This is to certify that Egr - Plantation Vistas Inc/Tr Contract
has permission to Repair fire damage in existin unit buildg
AT 988 Washington Ave
CITY OF PORTLAND 161 B025001

City of Portland, Maine - Building or Use Permit Application

Past Use: Residential 2 Unit	Proposed Use: Residential 2 unit / Repair fire damage in existing 2 unit building	Permit Fee: \$273.00	Cost of Work: \$28,000.00	CEO District: 4
Proposed Project Description: Repair fire damage in existing 2 unit building		FIRE DEPT: N/A	INSPECTION: Use Group: R Type: SB IRC 2003

2nd Floor

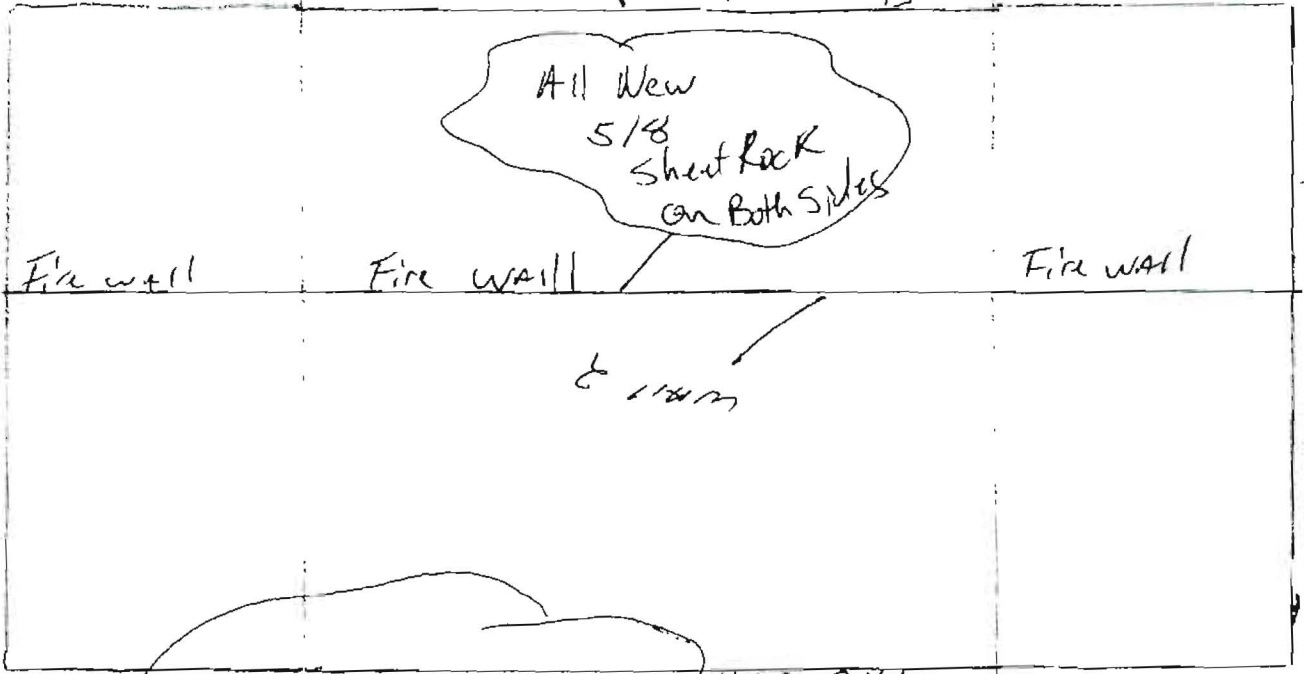
Comments:
 2/10/05-tmm: Left message for contractor - need fire wall detail as discussed at counter.

No work done on this wall

No work on Fire walls on 1st Floor

replace two sheets of 5/8 rock

3 walls
